**Southern Nuclear  
Operating Company, Inc.**  
40 Inverness Parkway  
Post Office Box 1295  
Birmingham, Alabama 35201

June 1, 2000

HL-5932

Edwin I. Hatch Nuclear Plant  
Request to Revise Technical Specifications:  
Pressure and Temperature Limits

Figure 3.4.9-1 (page 1 of 1)  
Pressure/Temperature Limits for  
Inservice Hydrostatic and Inservice Leakage Tests

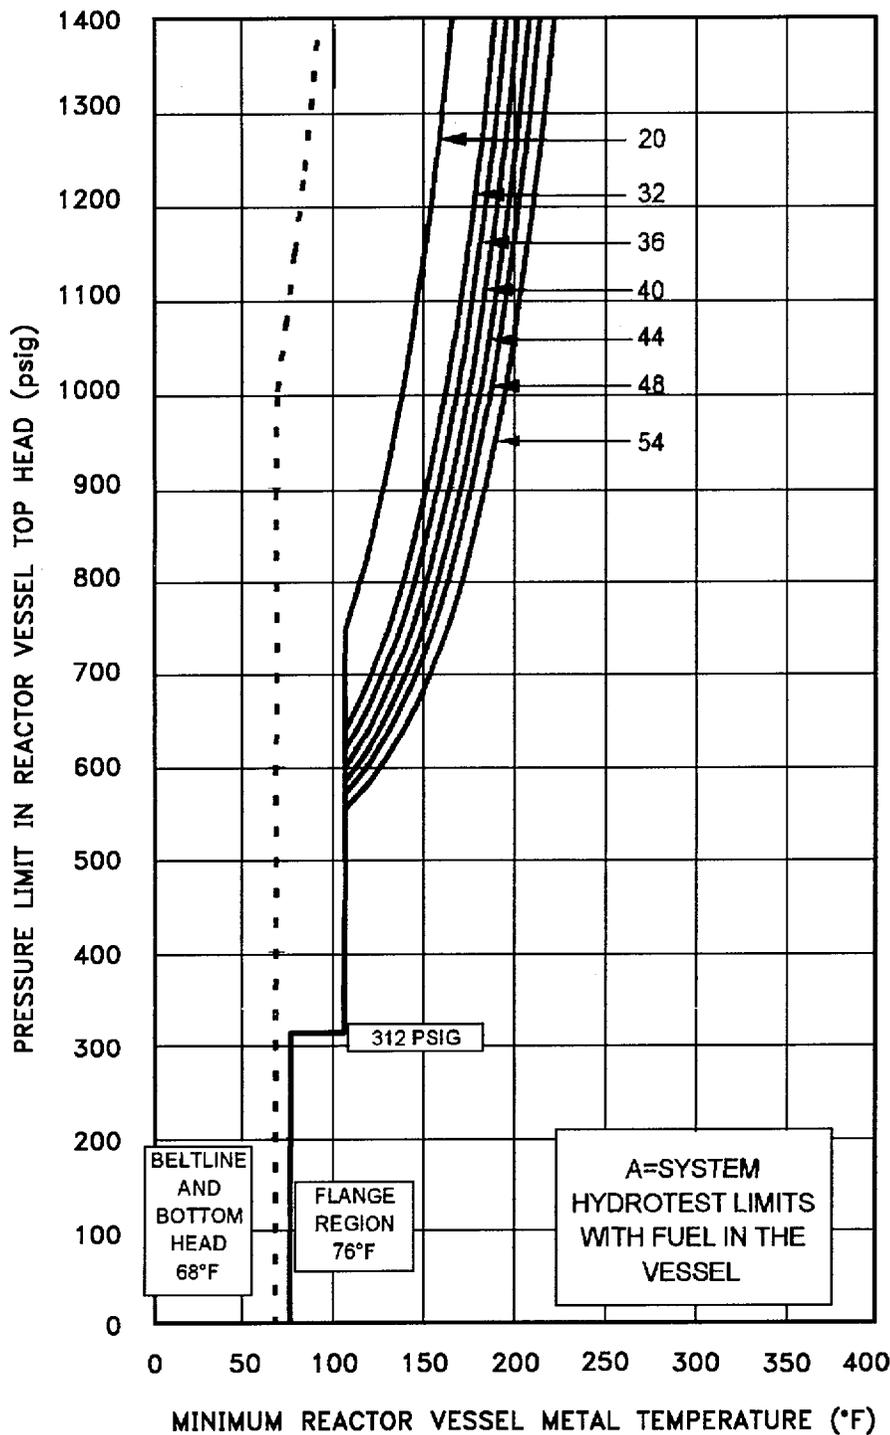
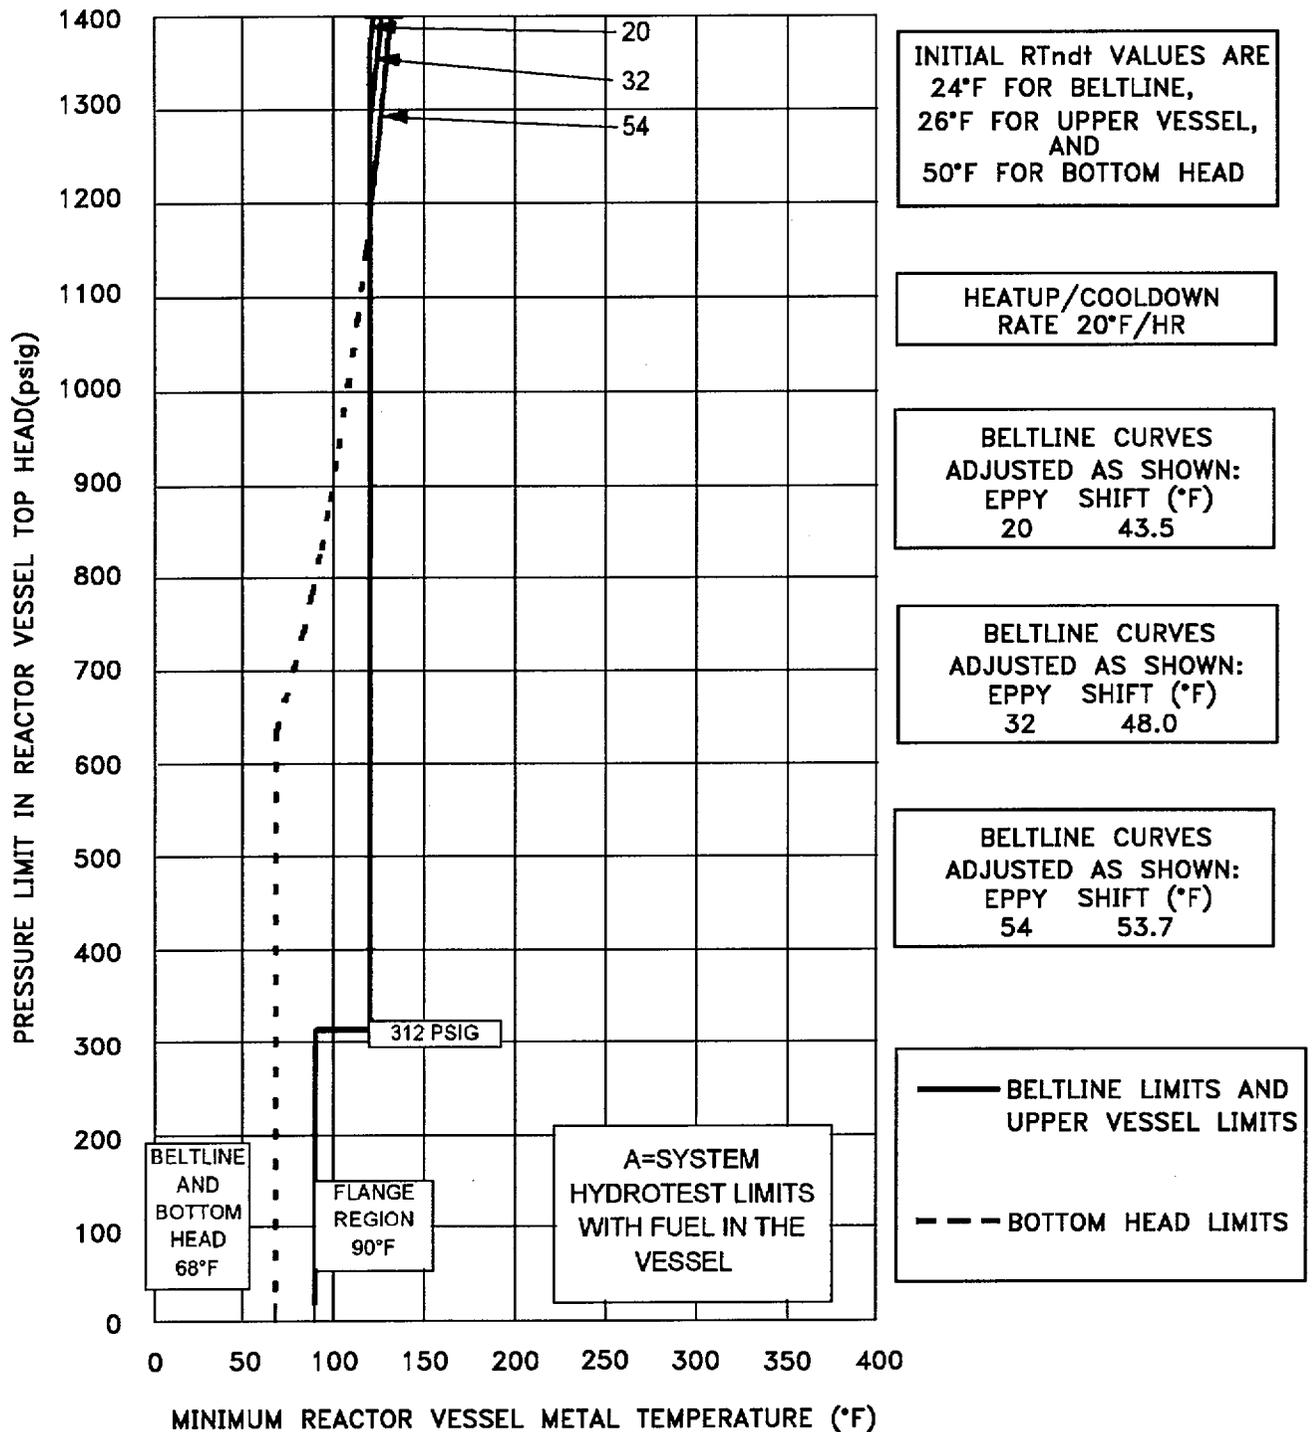
1. Make use of ASME Code Cases N-588 and N-640.
2. Extend the validity of the curves to 54 effective full-power years (EFPYs). The purpose of the extension is to account for the possibility of an extended license for Plant Hatch. In addition, intermediate curves for 36, 40, 44, and 48 EFPYs are included due to the expected irradiation shift for the Unit 1 RPV. (These intermediate curves are included only in the Unit 1 pressure test curve.)

INITIAL RTndt VALUES ARE  
-20°F FOR BELTLINE,  
40°F FOR UPPER VESSEL,  
AND  
10°F FOR BOTTOM HEAD
